**Potential impacts of downstream passage
of fauna over a labyrinth spillway at
Lake Macdonald
Six Mile Creek**

Aquatic Biopassage Services
for Seqwater

**Addendum to Potential impacts of
downstream passage of fauna over a
labyrinth spillway at
Lake Macdonald
Six Mile Creek**

Figure 4. Low flow section of labyrinth spillway showing areas with high potential for strike (from AECOM Drawing 60451967 - 113).

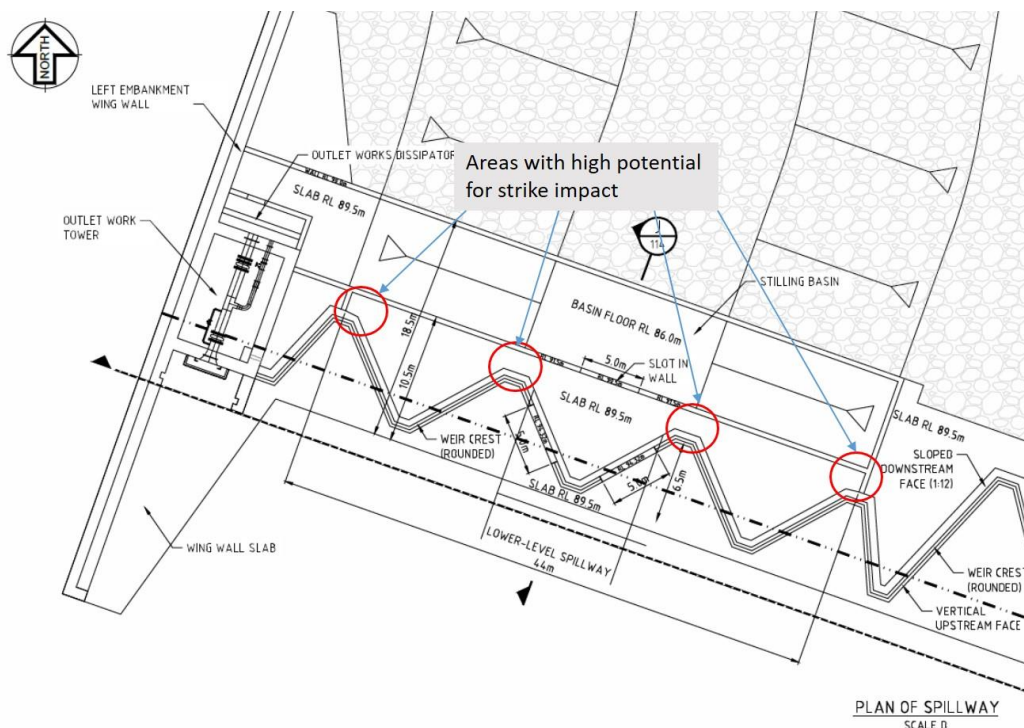
The stilling basin nib walls have the potential to cause injury to fish that strike them during overtopping flows; particularly at locations where the spillway is close to the nib wall as shown in Figure 4. Modelling of the flow patterns in both of the stilling basins using a technique such as 3D Computational Fluid Dynamics (3D CFD) will provide details to inform an improved wall arrangement.

Figure 1. Six Mile Creek Dam –Concept design of the original layout of the labyrinth spillway. (Provided by AECOM)

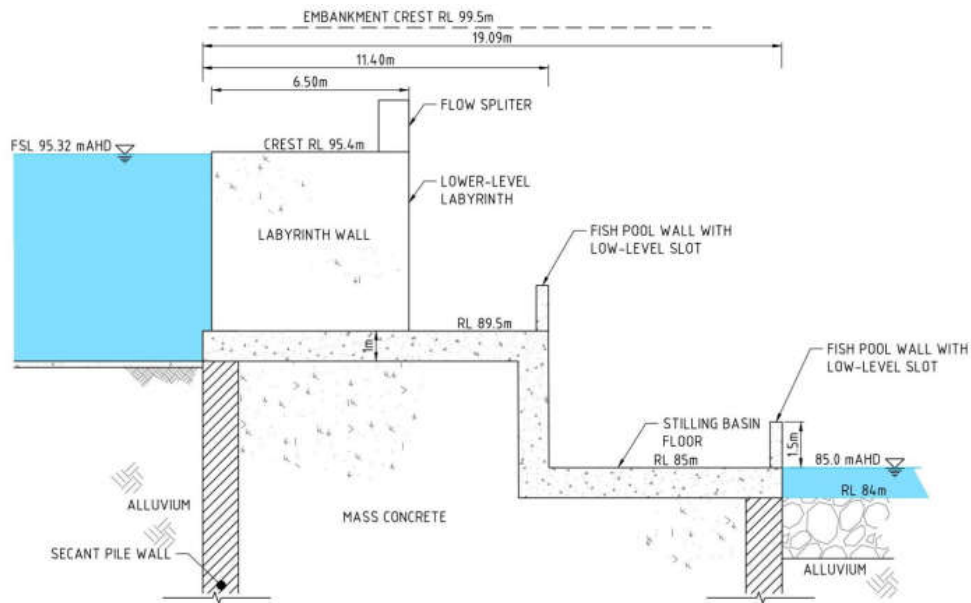
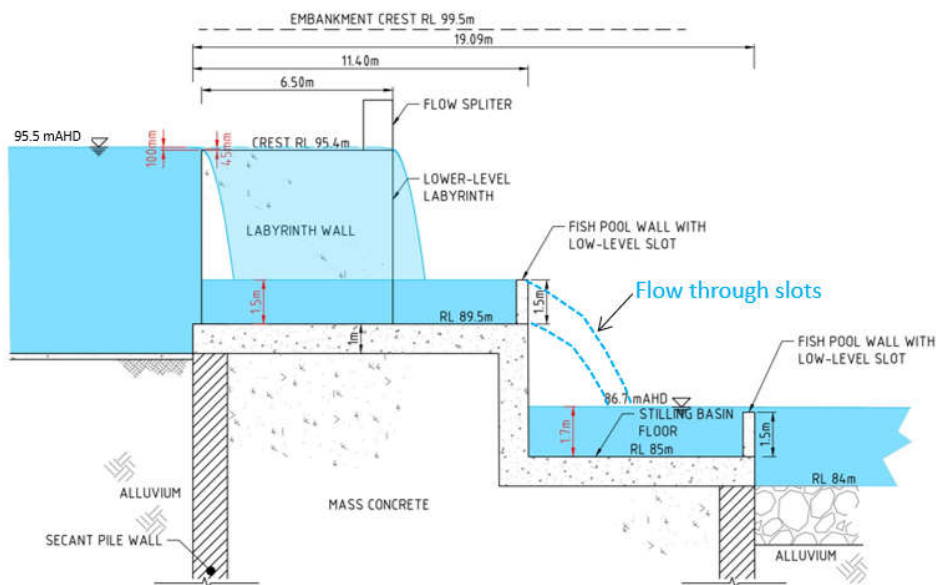
The crest shape selected for the proposed labyrinth spillway was a quarter round shape, which results in a rounded upstream crest and aeration behind the spilling flows to allow a free fall plunge. For fish passage, this arrangement leads to a smooth, rounded approach surface to the spillway crest as well as minimisation or avoidance of an abrasion source downstream of the crest on the vertical drop as is shown in Figure 2. However it should be noted that in low spillway overtopping flows, aeration may be ineffective in separating the spilling flow from the downstream vertical face of the spillway.

The design for downstream plunge pool walls is for rounded upstream crests to minimise sharp upstream edges, this is not shown in the early concept designs in Figure 1 and 2.

Figure 3. 3D sketch of concept design labyrinth spillway and plunge pools (Configuration 1)
(Provided by AECOM)

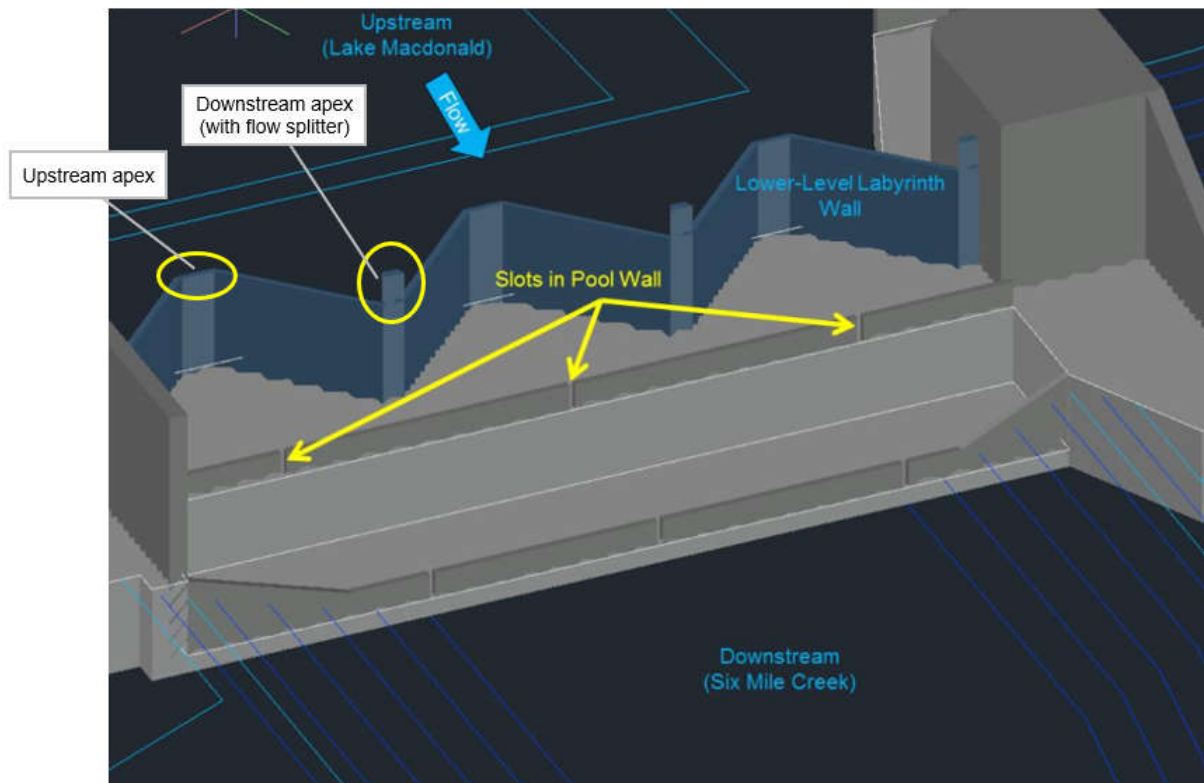
Configuration 1: Original layout (upper pool depth = 1.5m; lower pool depth = 1.5m):

- The 100 mm spillway overtopping flow had the potential for vertical flow from the spillway to cause abrasion for fish passing along the spillway wall.
- At overtopping flows of 300 mm and 600 mm, flows at the upstream apex of each labyrinth trapezoid cycle fall vertically against the spillway wall, with potential for abrasion.
- At overtopping flows of 300 mm and 600 mm high velocity areas where the flow jet hits the stilling basin floor and dissipator wall may have caused strike injury.
- At the 600 mm overtopping depth, flow patterns within the stilling basin indicated a highly turbulent condition that may have injured and disoriented fish.

Figure 4. Cross-section of single pool labyrinth arrangement (Configuration 5)

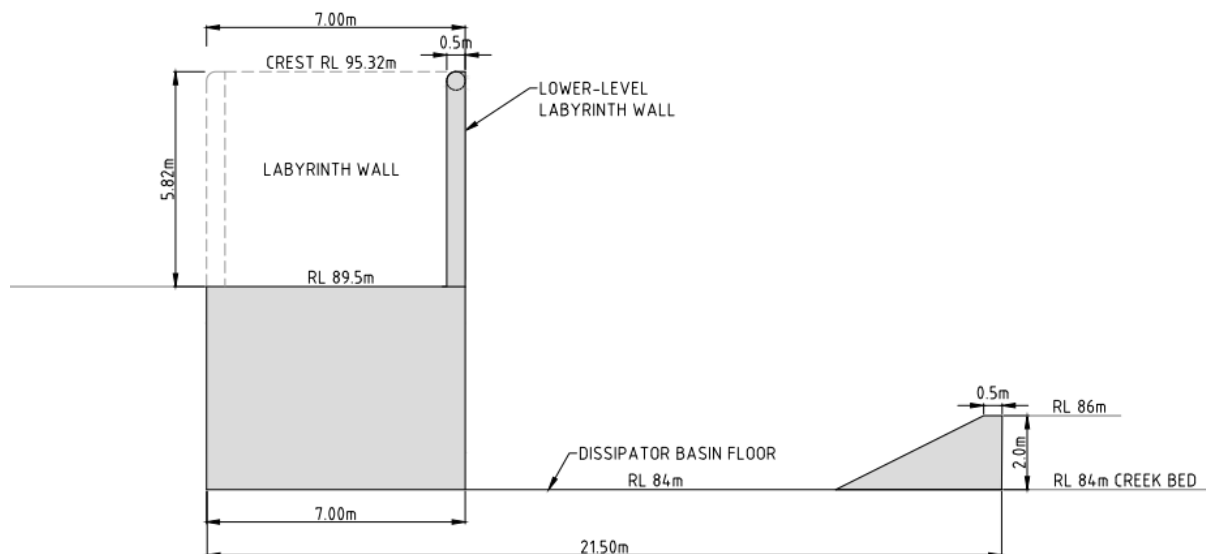
Configuration 5, with a single pool arrangement, has been selected as the final plunge pool design to move forward to detailed design. A cross section of this configuration is provided in Figure 4. The CFD modelling produced by AECOM for the latest iteration of the Configuration 5 plunge pool design indicates favourable conditions for flow over the acute angle sections of the spillway. Issues with high velocity and potential for abrasion are eliminated for the lower range of flows and reduced to

Further development of the Configuration 5 design has retained the single drop with the floor set at RL 84.0 m AHD (approximate creek bed level) and a lower sloped nib wall at the downstream end. The single drop configuration will lead to a higher vertical fall compared to the double plunge pool configurations. The maximum fall is estimated to be 10.32 m into a 1.0 m deep pool at commence to flow.

The tailwater level in Six Mile Creek rises rapidly during flow and by the time a 100 mm overtopping flow occurs the fall scenario is lessened to a 7.92 m fall into a 3.4 m deep tailwater pool. Table 1 below provides the range of flows up to the 1:100 AEP with the predicted overtopping levels, plunge pool depth, fall height from headwater surface to tailwater surface and pool depth as a percentage of fall height. In all flow cases over 100 mm overtopping, the maximum fall height is greater than the 30% spillway drop to plunge pool ratio recommended as a starting point by Berghuis (2017). Furthermore, none of the fall heights exceed the predicted fish injury threshold of 13 m, as outlined in Ruggles and Murray (1983).

Figure 1. 300mm overtopping CFD model run slices through spillway section at an acute angle (a) and upstream apex section (b).

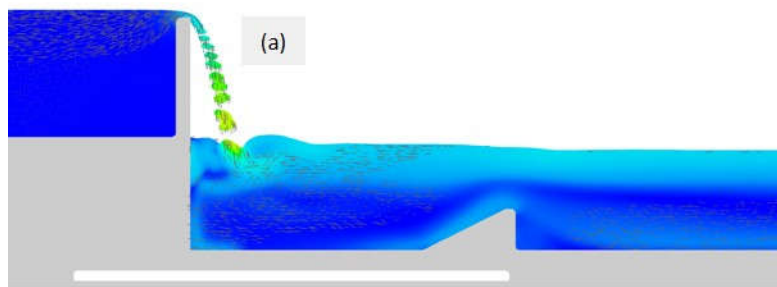
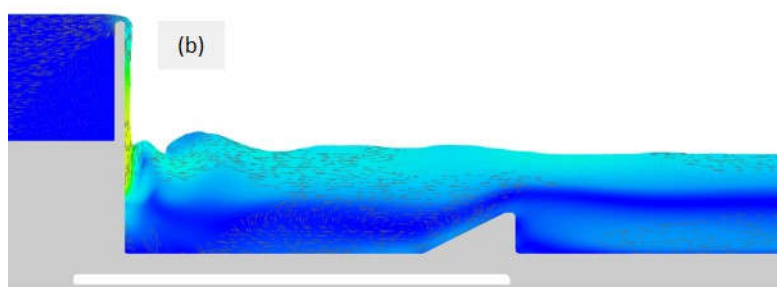
Flows over the upstream apex section continue to present potential issues with spillway abrasion at the 300 mm overtopping flow and potential for injury during flows of 1.0m overtopping and above. The issue does not appear to be related to the plunge pool design but rather to an effect known as nappe interference, which is described in Falvey (2003) as an effect caused by the flow over the acute angle crest influencing the flow from the upstream apex section of the crest. Further development of the plunge pool arrangement is unlikely to improve the impact of nappe interference downstream of the crest, within the range of flows where it may be an issue for fish.
